Tier 1 Project: New Jefferson Elementary School

CHANGE ORDER NUMBER: 21-9
INITIATION DATE: 8/19/2021

Project:	Jefferson Elem School 800 S Alves Ave Henderson KY	PR No.:	009
		Date:	May 10, 2021
Owner:	Henderson County Schools 1805 2nd Street Henderson KY	Project Number:	1807-244
		Contract for:	Discipline
To:	John Hagan Codell 4475 Rockwell Rd Winchester KY		
RE:	Basin #3 – Slope Remediation

Slope Remediation Investigation

STABL6H FSmin=1.02
Safety Factors Are Calculated By The Modified Bishop Method

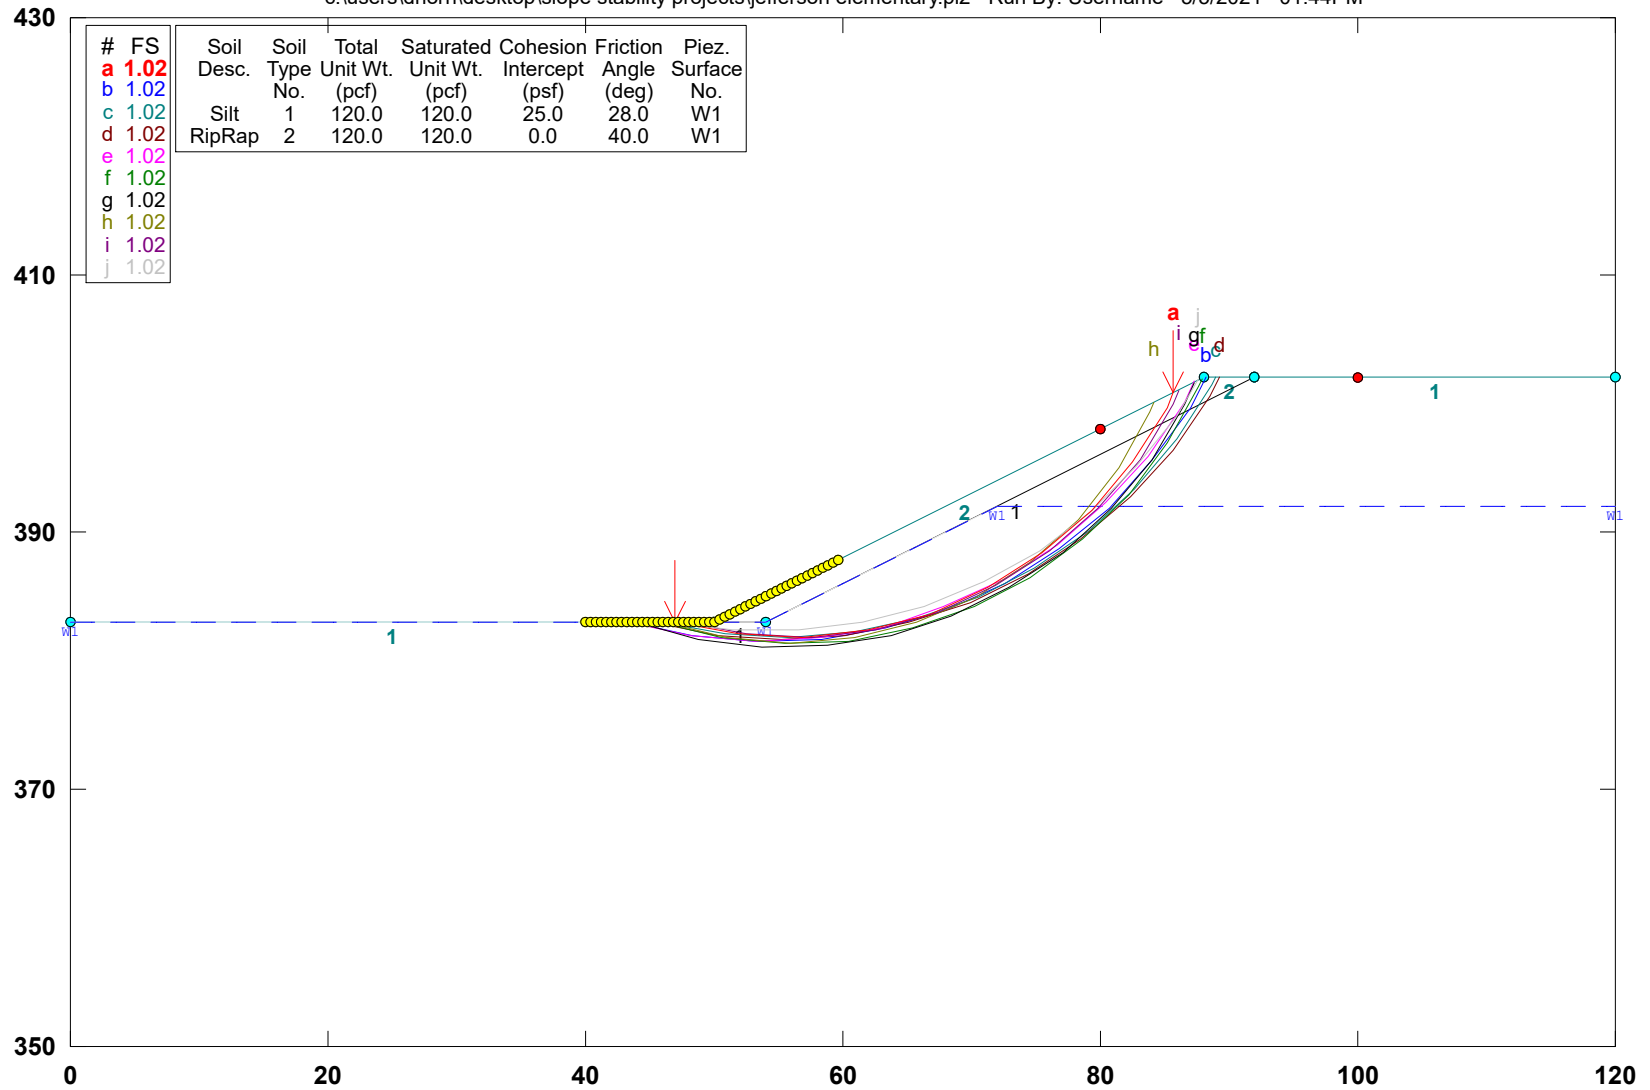
A cross section of the embankment was taken prior to failure of the failing slope area, for a slope stability analysis. A grading plan prepared by QK4, Inc. dated October 2019 was used for modeling of our analysis. The analysis assumed that the elevations provided on the grading plan were as built. The analysis assumes that the slope will be reconstructed at or near the elevations outlined in the grading plan. A slope stability analysis was performed using Stedwin, a computer-modeling program created for the analysis of slopes and slope failures.

Soil properties were determined from a visual inspection of the face of the failing slope, the previous Alt & Witzig subsurface investigation (18EV0070), and our experience with soils in this area. Bishop Circular Search method and sliding-block analysis was used to generate various possible surface failures. The slope was first modeled with a factor of safety of 1.0 to imitate the existing failing conditions. Several options were considered to remediate and protect the slope, including rip-rap and a reinforced slope. The results for the slope stability analyses are attached to this report. In a slope stability analysis, a factor of safety of 1.0 is considered unstable and in a mode of failure. The slopes were modeled until a factor of safety of 1.3 was achieved.

STABL6H FSmin=1.30
Safety Factors Are Calculated By The Modified Bishop Method

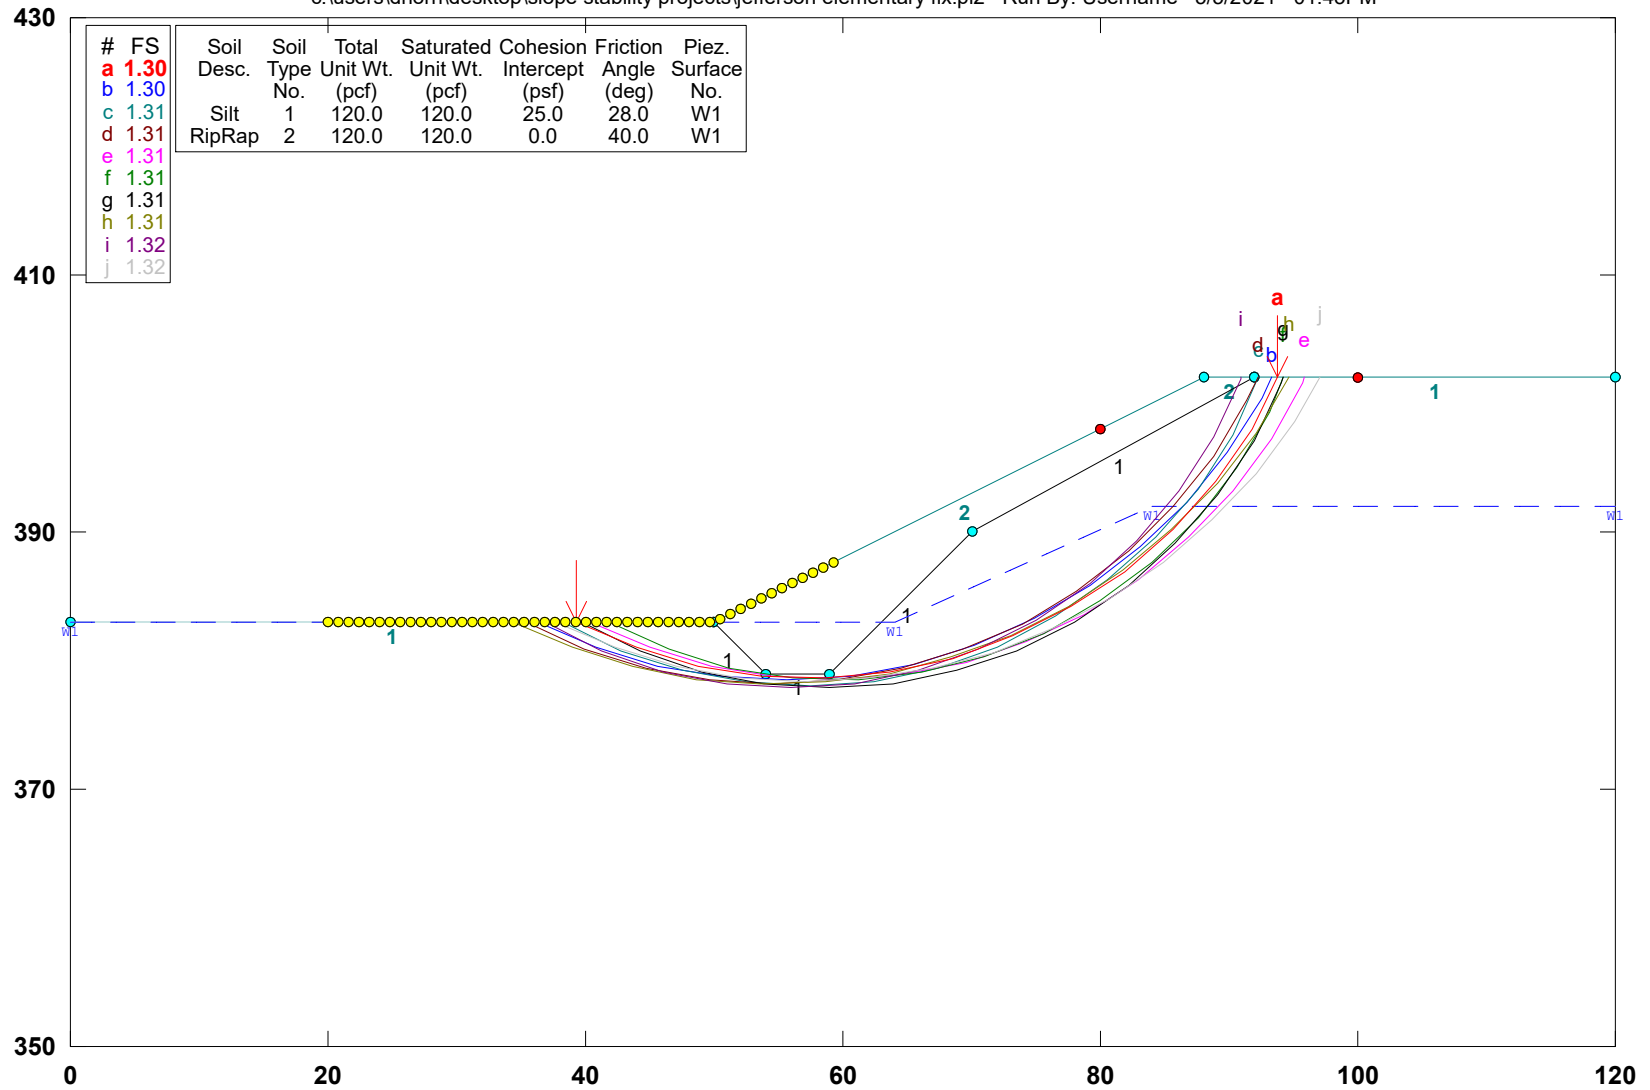
For either option we recommend complete removal and replacement of failing soils/fills. We recommend that permanent slopes no steeper than 2.5:1 (H:V) be constructed without protection. The structural fill will require proper benching techniques performed in accordance with project plans and specifications. All benches should be of sufficient width to accommodate the required compaction equipment. All fill-slopes should be overbuilt and then cut back to the proposed grade to assure that compacted material exists at the face of the slope.

Rip-Rap Cross Section

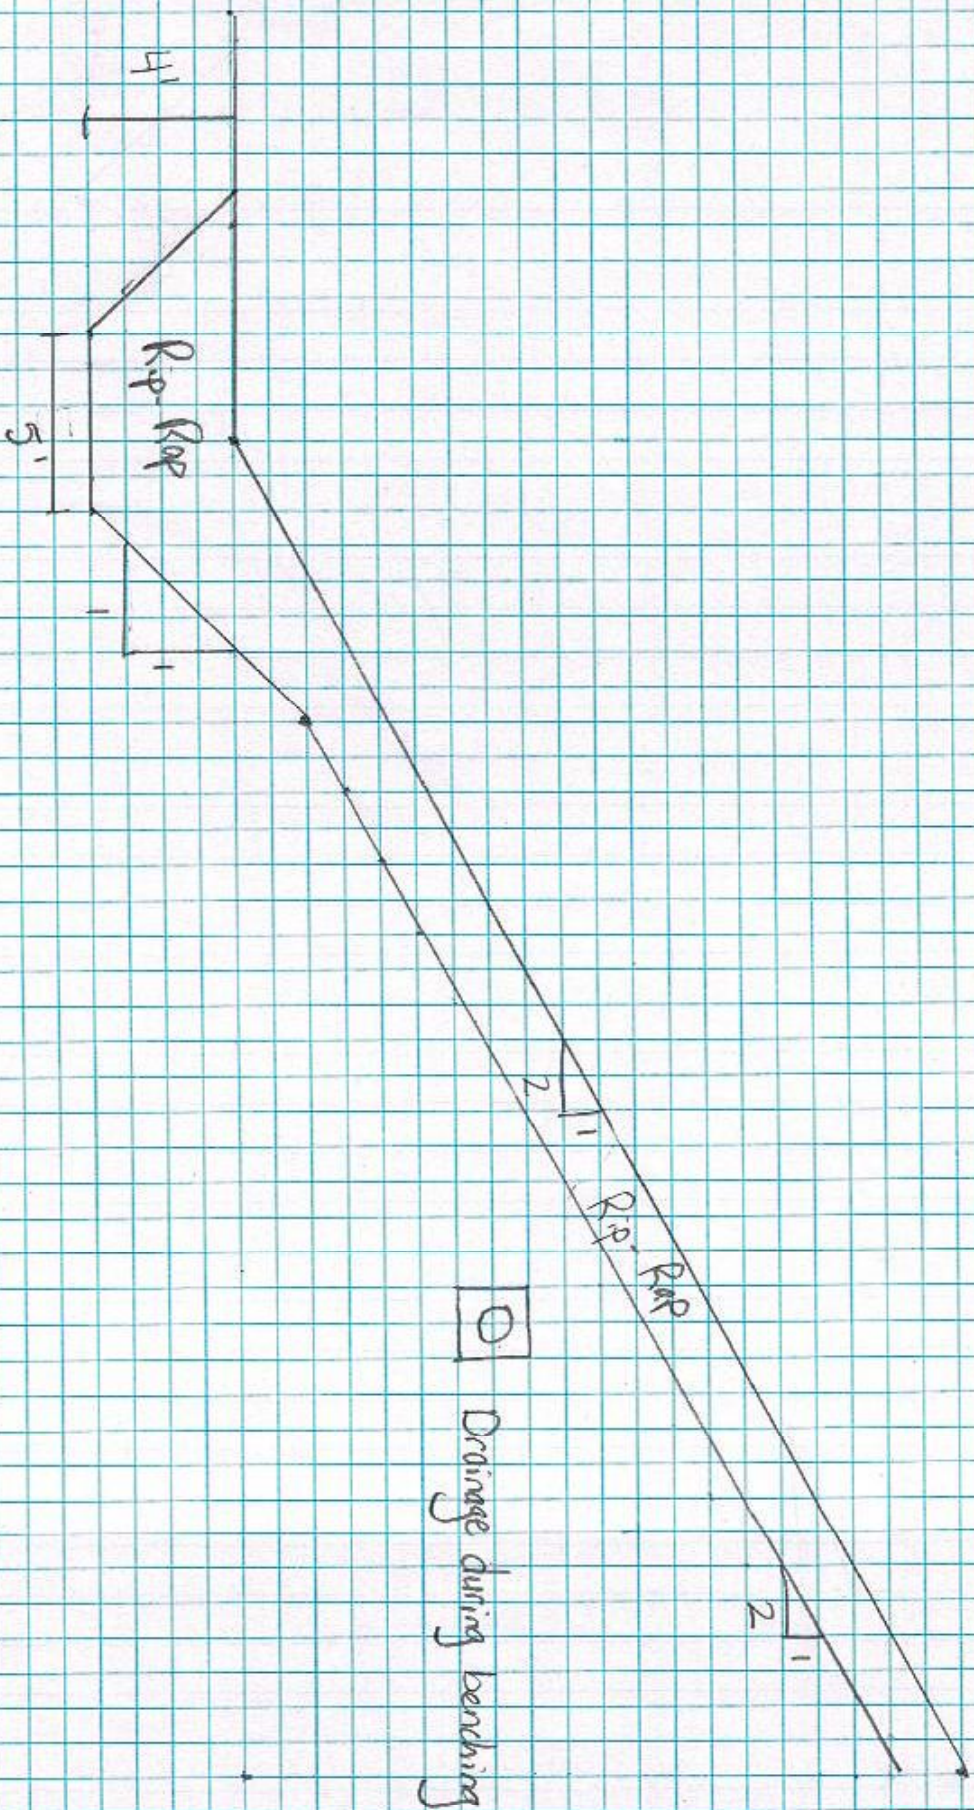
Rip-Rap: Riprap could be used to protect the slope. A 4' deep key, 5' wide at the base would be needed with riprap coming up to halfway up the slope at 2:1 as designed. At this point the riprap just becomes around 2' thick. The geometry can be seen on the attached *Rip-Rap Cross Section*. Drainage needs to be included during reconstruction of the slope to keep water out of the slope face. Drains will be required along benches assuming to near elevation 390' and 395'. The drains should consist of a 4-inch perforated socked tile covered surrounded by a minimum of 2 feet wide and 2 feet deep of well-draining granular soils.

STABL6H FSmin=1.30
Safety Factors Are Calculated By The Modified Bishop Method

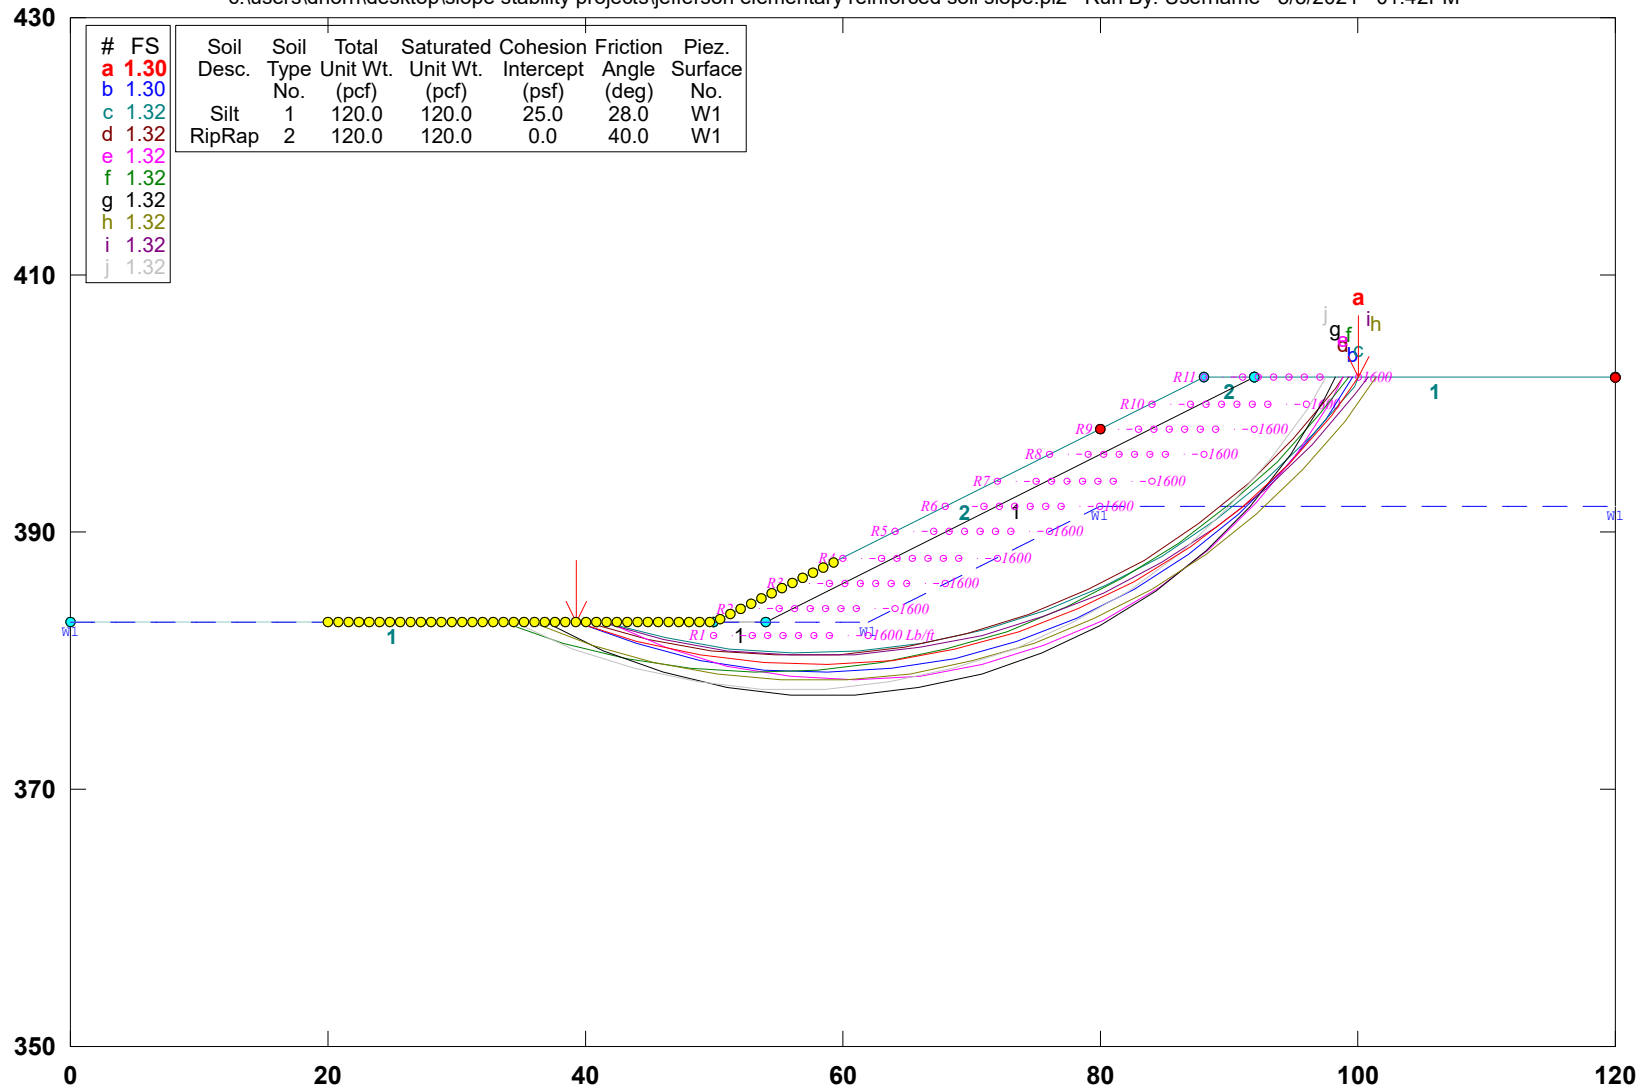
Reinforced Soil Slope: Our analysis indicated that a reinforced soil slope with 12ft long grids could be used to protect the slope. Anything below 12' was indicated a factory of safety less than 1.3. The grids/fabric should need to be wicking to drain the slope as well. All reinforced slopes should be designed by a registered engineer and must include their own separate internal and global stability analyzes. Depending upon the results of the global stability analysis, additional grid length could be required to obtain minimum factors of safety.
